**ADDENDUM  
APPROVAL CRITERIA AND FINDINGS  
MIP-17-04**

**CITY OF WEST LINN  
NOTICE OF UPCOMING  
PLANNING MANAGER DECISION  
FILE NO. MIP-17-04**

1560 ROSEMONT RD.  
 Tentative Plan

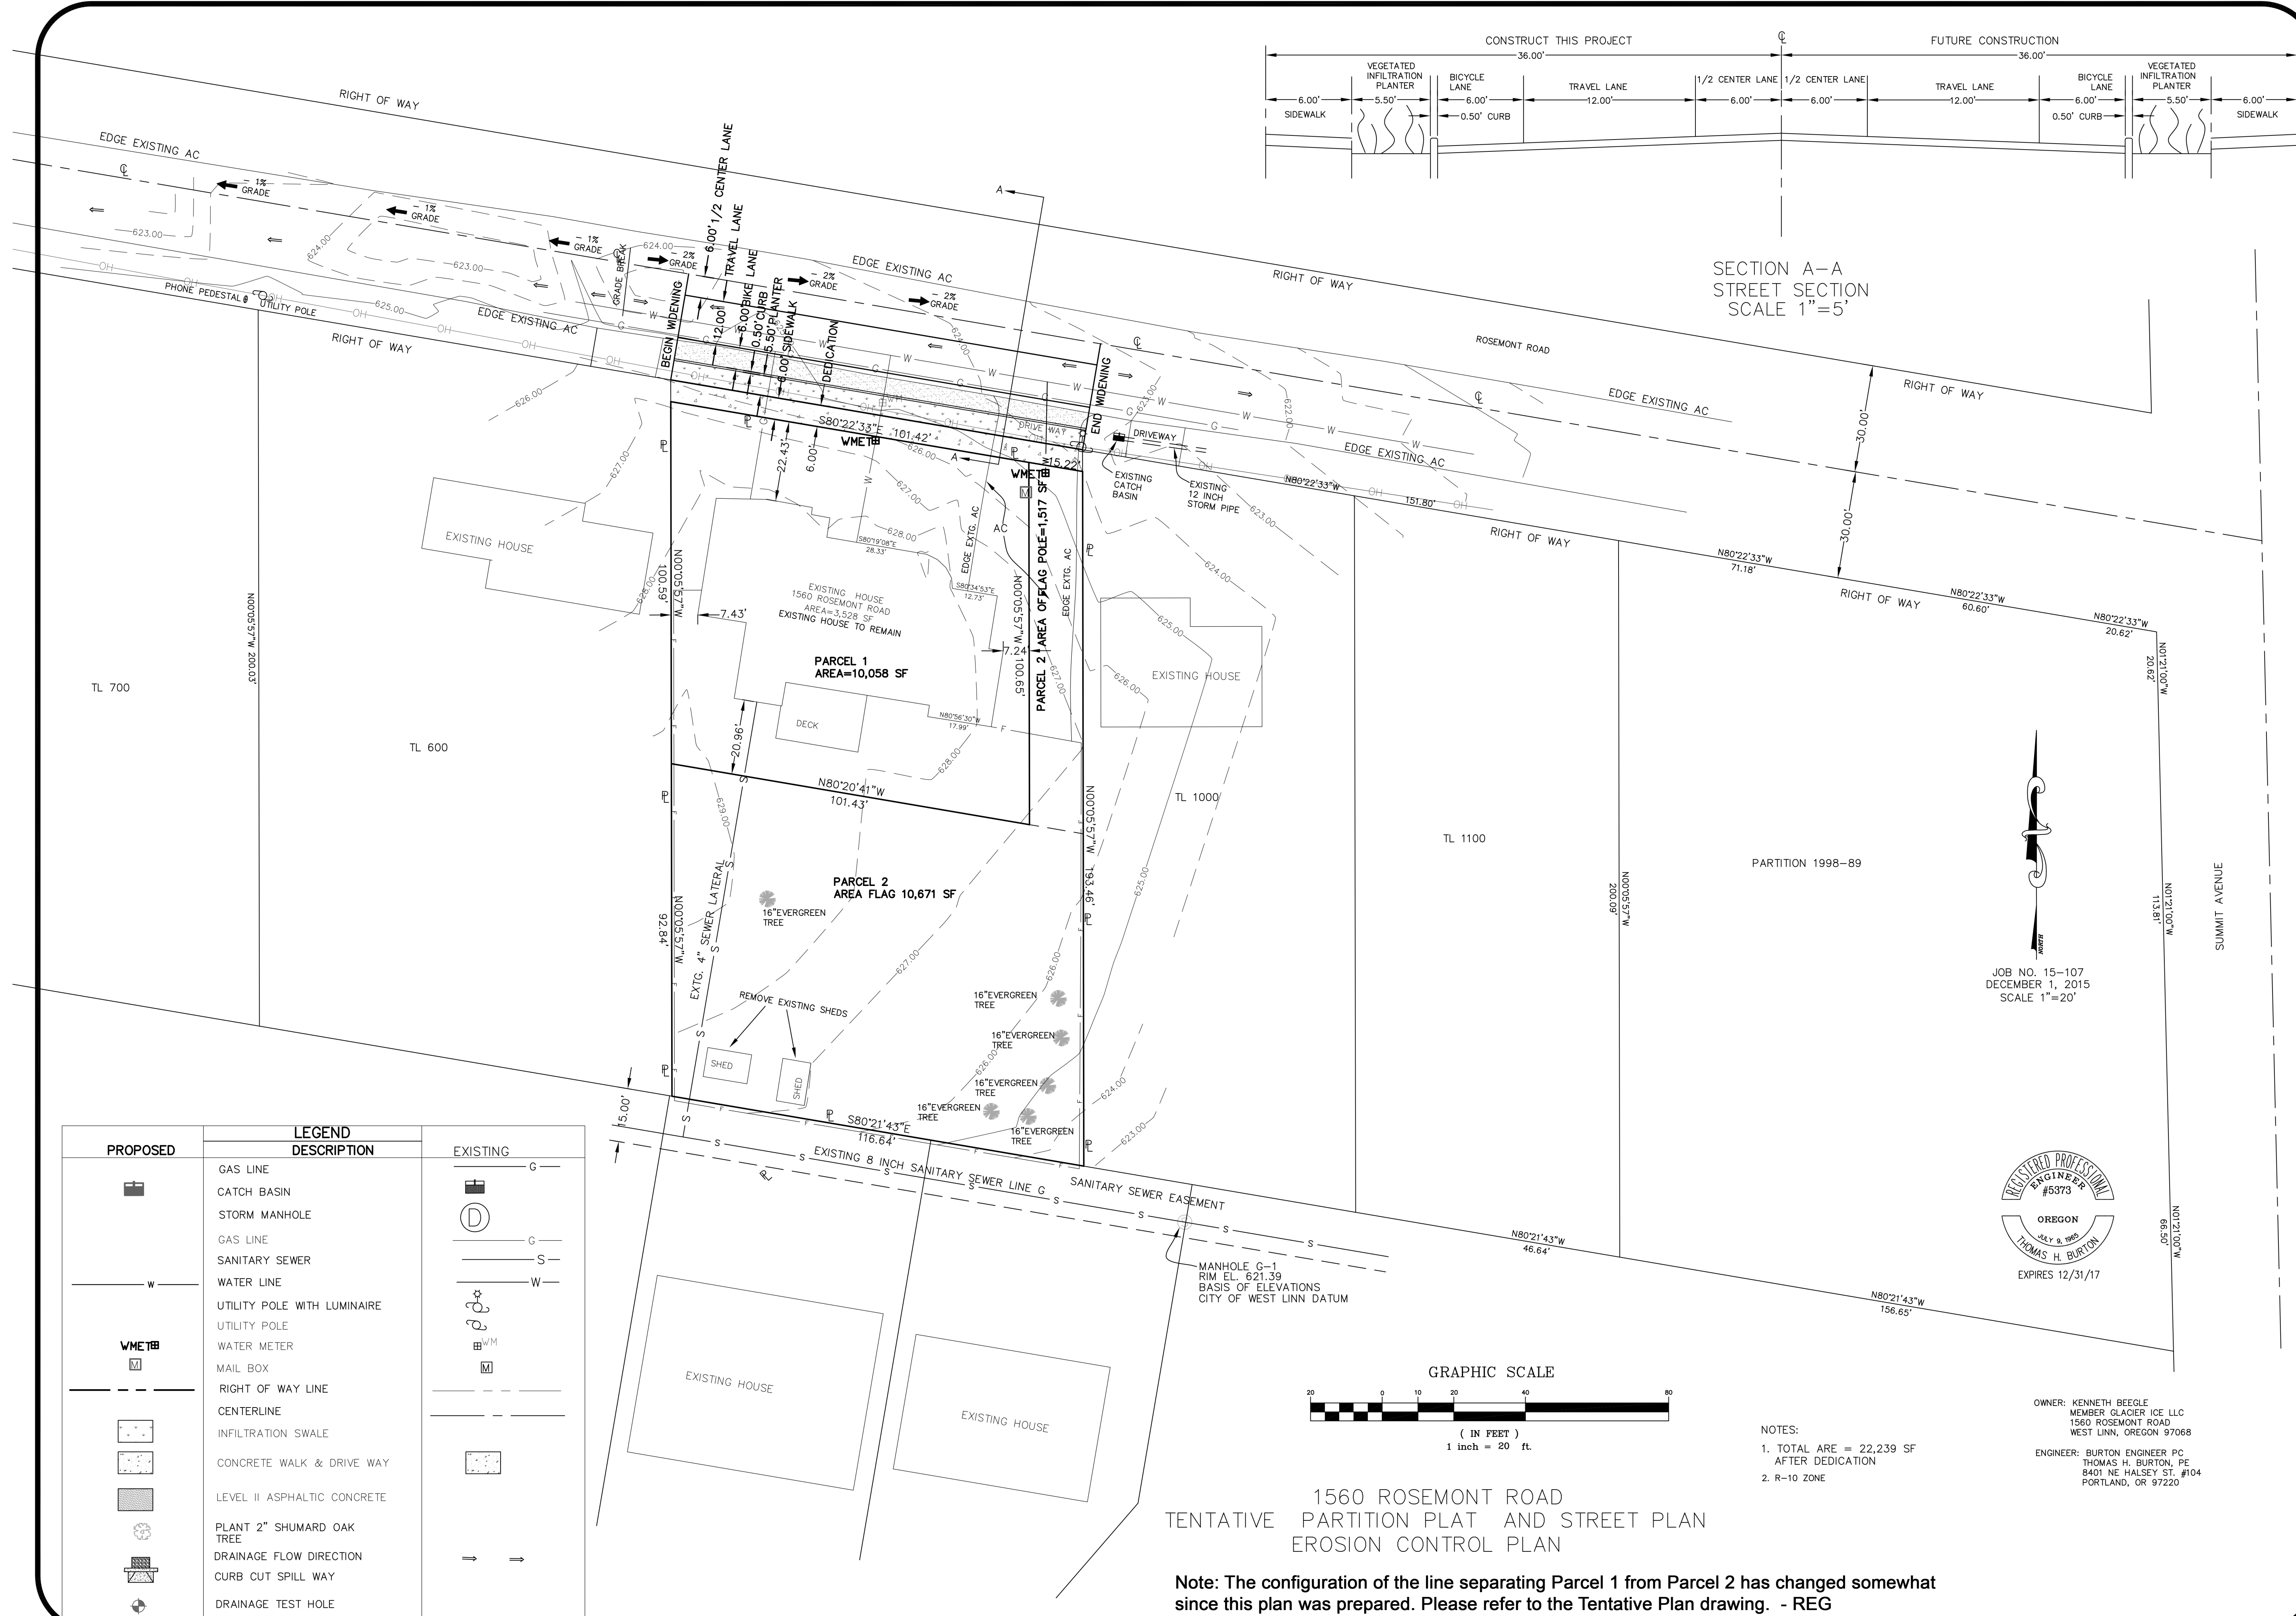
1. **Site Plan.** With the exception of modifications required by these conditions, the final plat shall conform to the Tentative Plan dated July 2017 (Exhibit PD-5, page 22).
